Traffic Engineering Expert  
Evidence  
Fingerboards Mineral Sands  
Project  
Inquiry and Advisory Committee  
1 February 2021

**Expert Evidence**

East Gippsland Shire Council

Our reference 17657T-REP01aFinal

Figure 2.5 Proposed Road Deviations

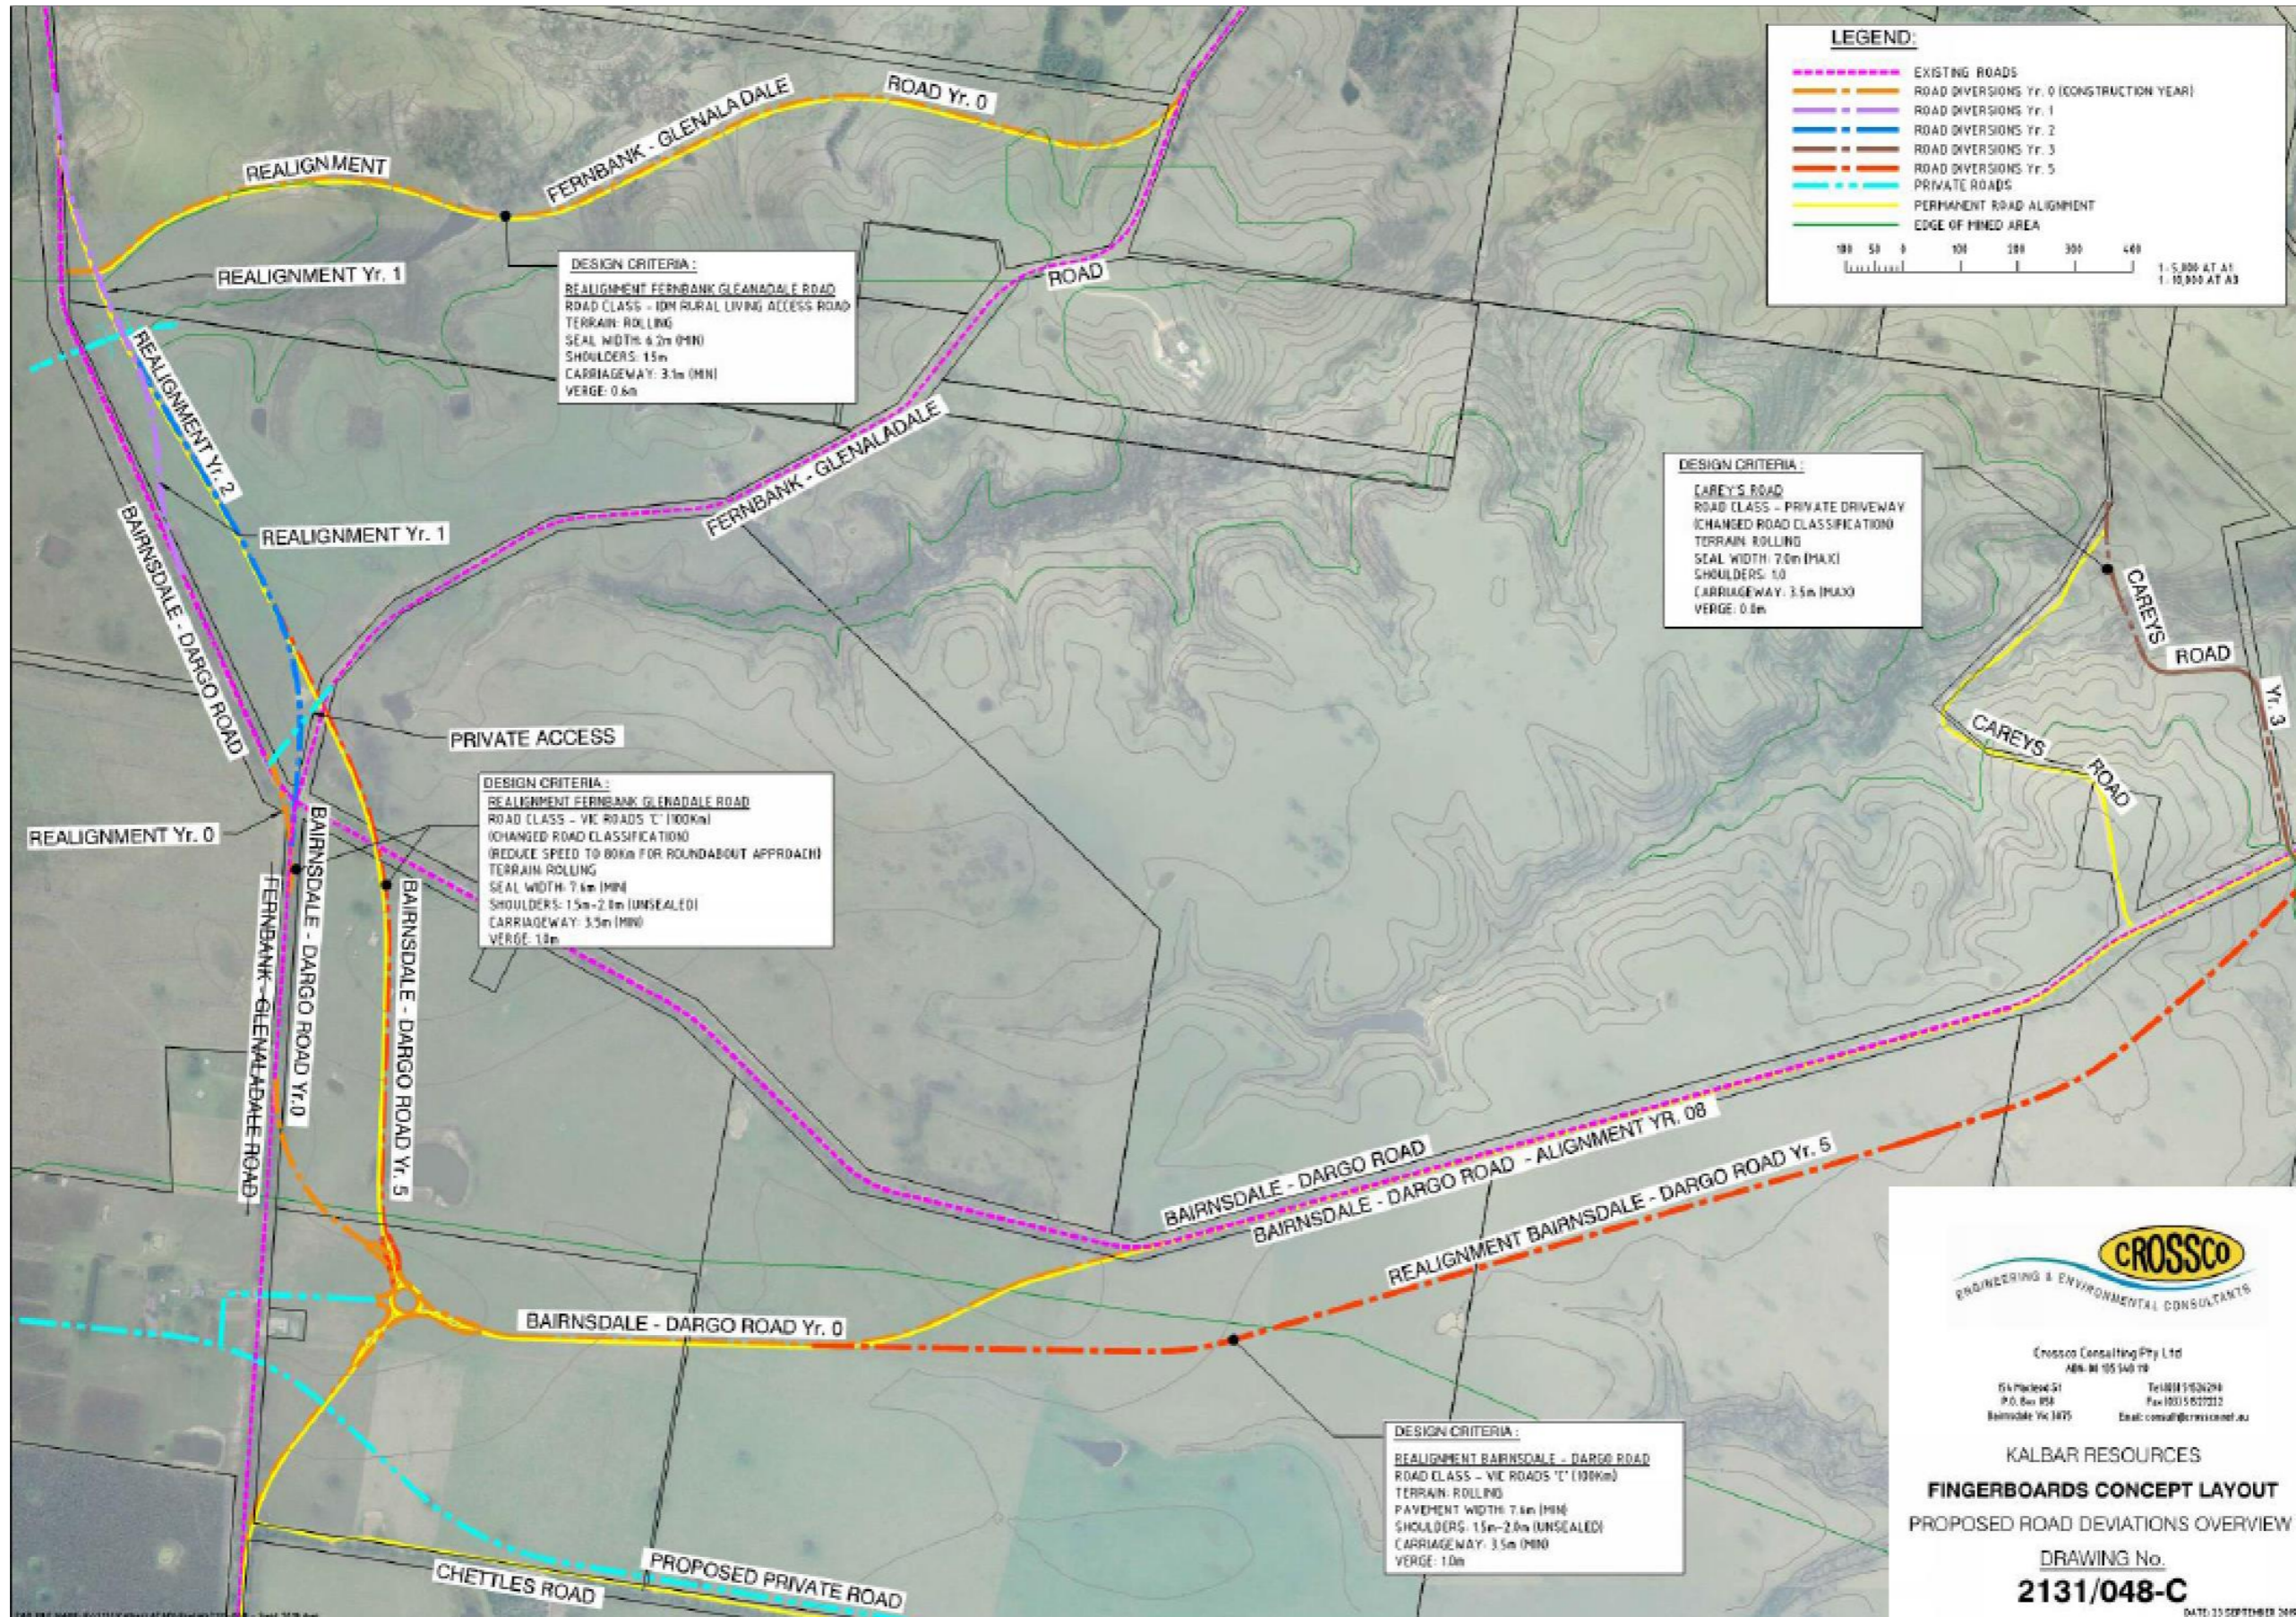
- 2.3.1 The road deviations, which are understood to be required to facilitate mining activities during different stages of the project are described as follows:
- Removal of the existing Fingerboards Intersection,
  - Construction of a new 4-leg roundabout to the south east of the existing Fingerboards intersection, with the western leg forming the main access road into the site.
  - Realignment of Fernbank-Glenaladale Road to the north of Bairnsdale Dargo Road to the west and between Bairnsdale Dargo Road and Chettles Road to the east to meet the new roundabout.
  - A new intersection on Ferndale- Glenaladale Road with the private haulage road between the new roundabout and Chettles Road, assuming the construction of a purpose-built rail siding at Ferndale East in the Post Avon Option 1 scenario is pursued.

**Figure 5.1 Revised Fingerboards Roundabout Design**

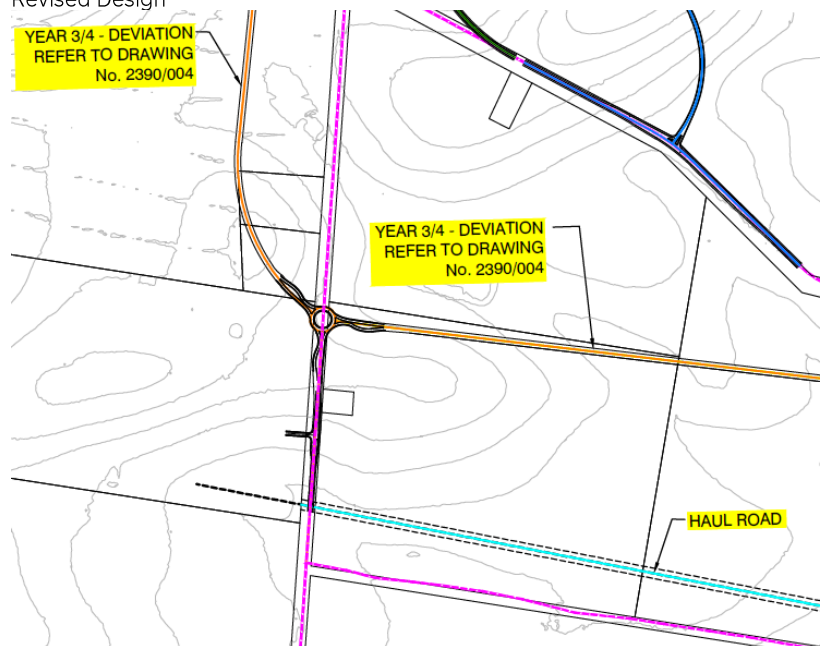
- 5.2.3 It is noted that the redesign, while continuing to relocate the Fingerboards intersection to the south and convert it to a roundabout, seeks to retain the existing alignment of Fernbank-Glenaladale Road south, with the intersection forming a three-leg roundabout as shown in Figure 5.1

- 5.2.5 While the revised road alignment reduces to extent of deviations required and appears to remove the issue of land acquisition from other landowners, it does not in my opinion resolve the issue of the separation of intersections along Fernbank-Glenaladale Road or the control of the intersection of the private haulage road and Fernbank-Glenaladale Road.

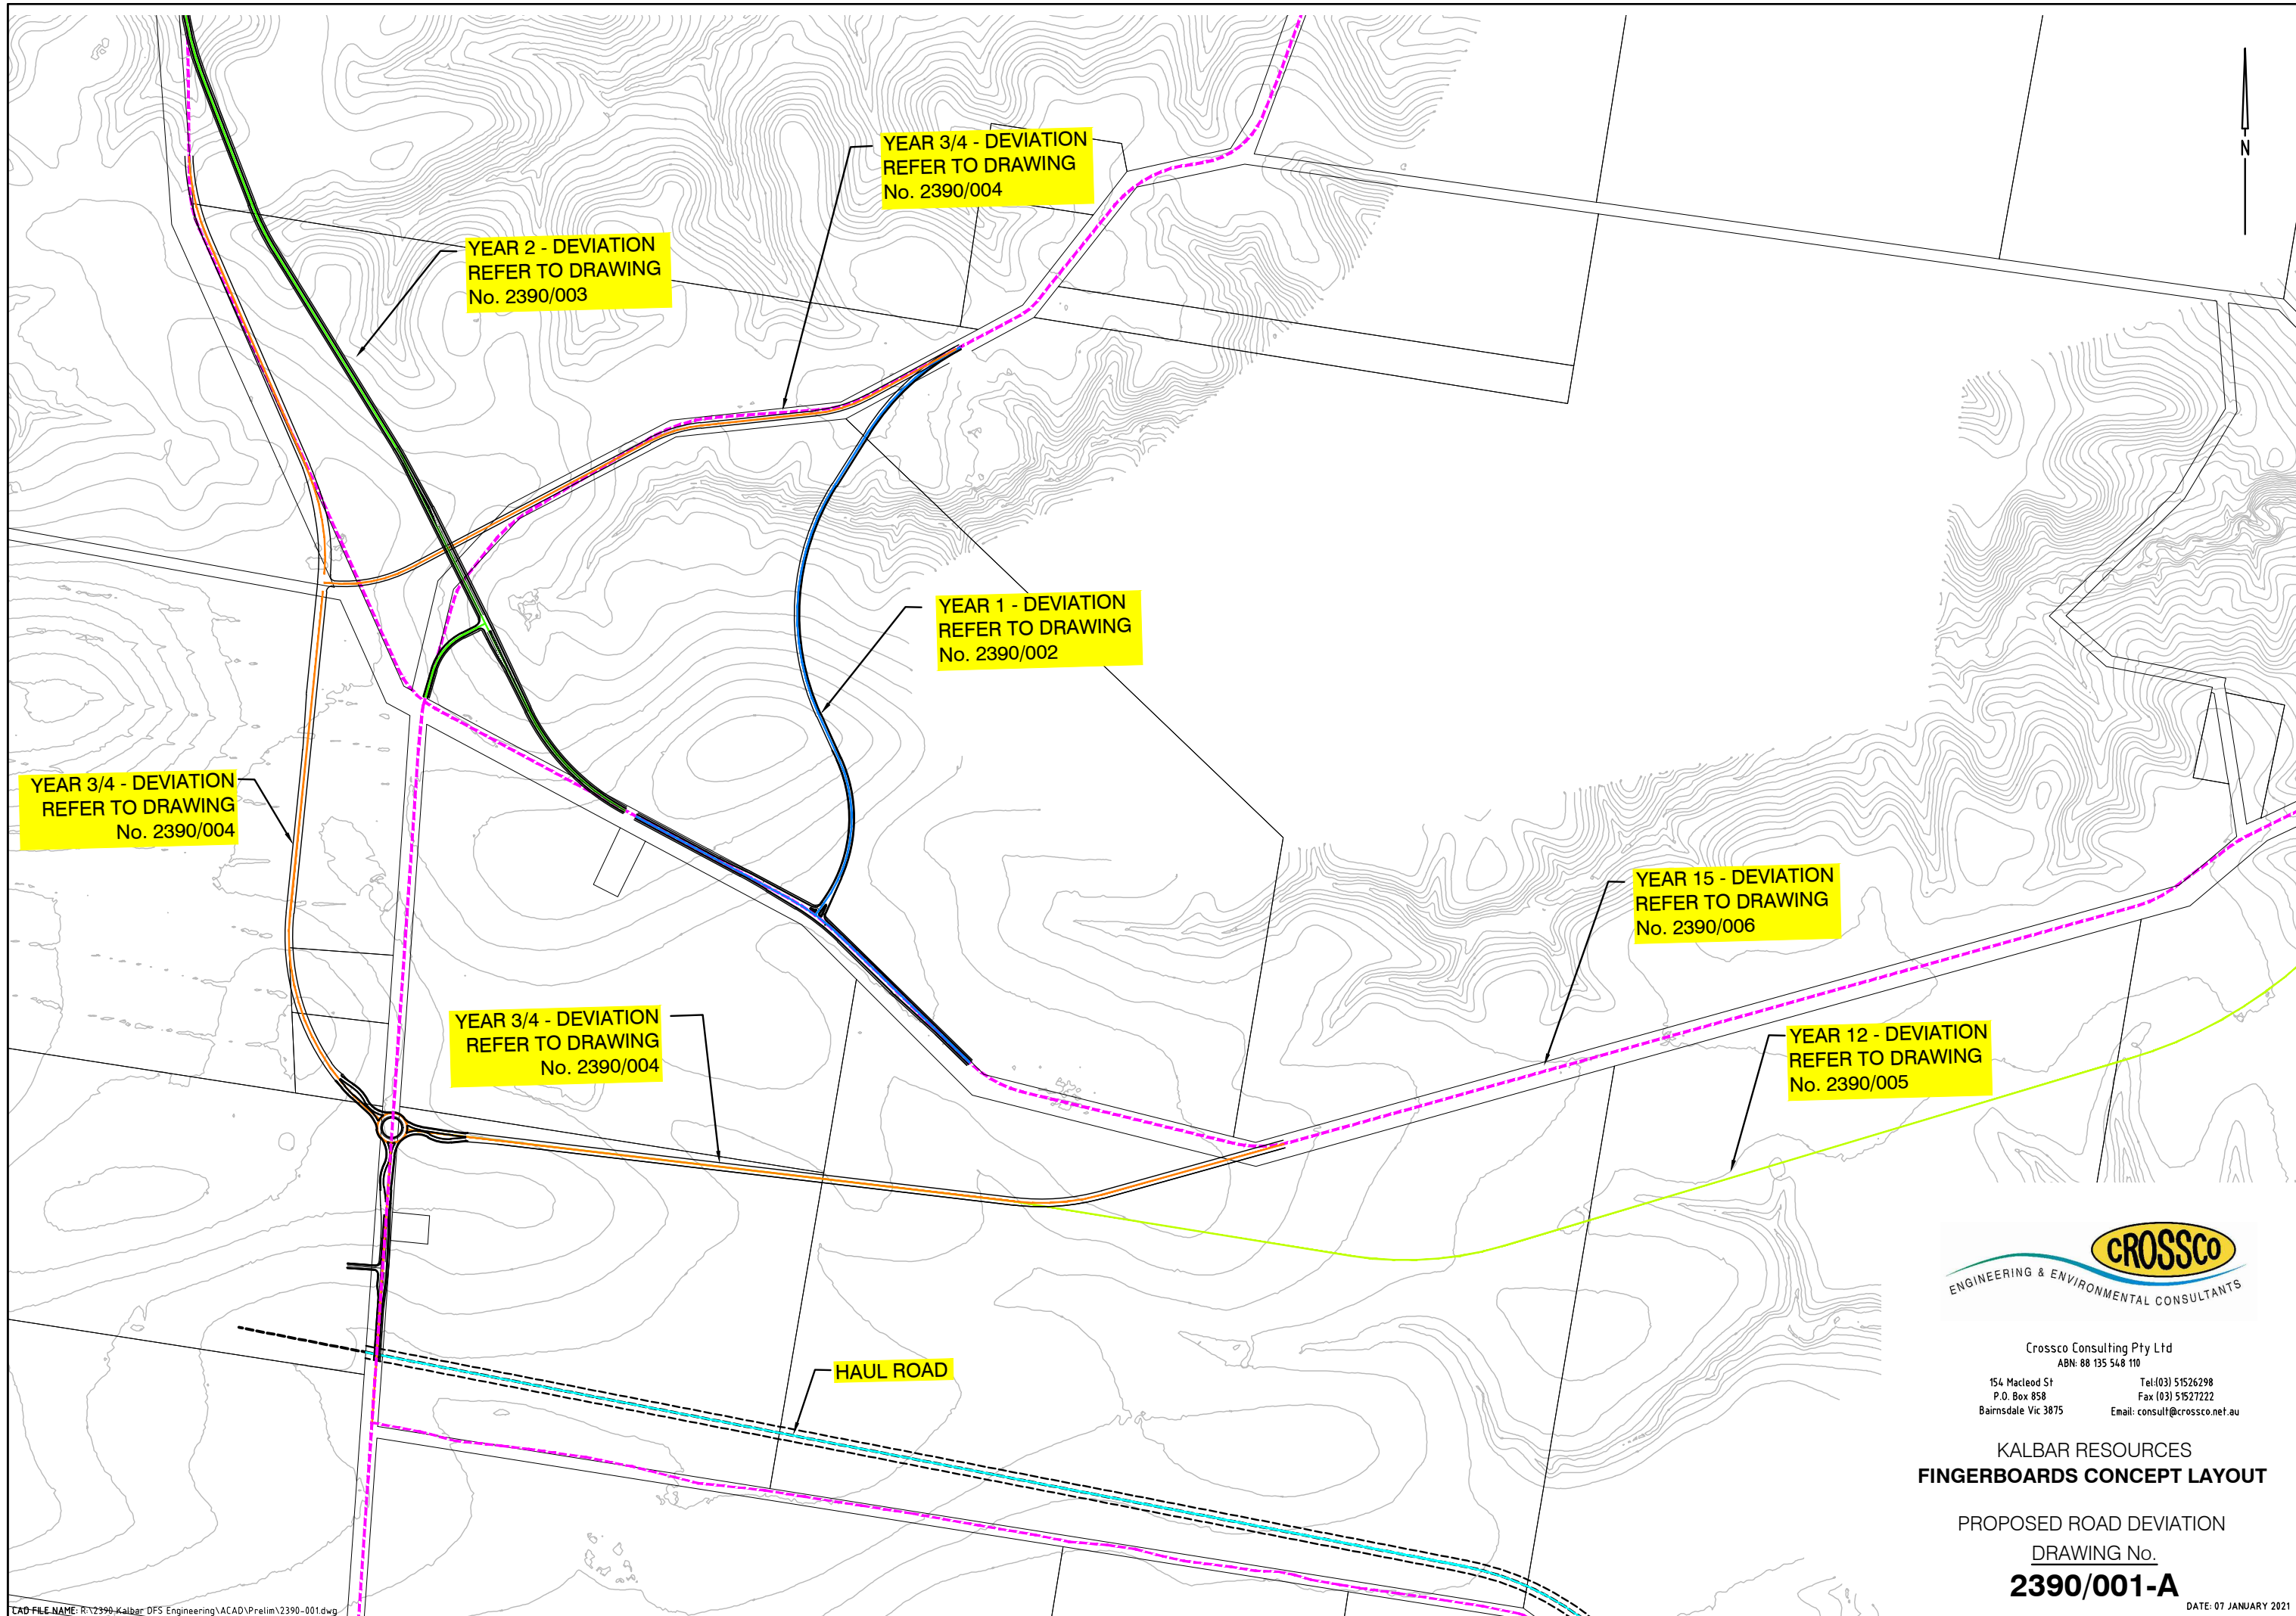
6.1.15 Clarification should be provided with respect to:

- The proposed relocation of the site access to the south of the Fingerboards roundabout rather than as a fourth leg to the roundabout as exhibited,
- The need for the Fingerboards intersection to be roundabout control,
- The control of the proposed site access point and separation from the intersection.

6.1.16 In my opinion, the Private Haulage Road should be designed to pass under Fernbank – Glenaladale Road.
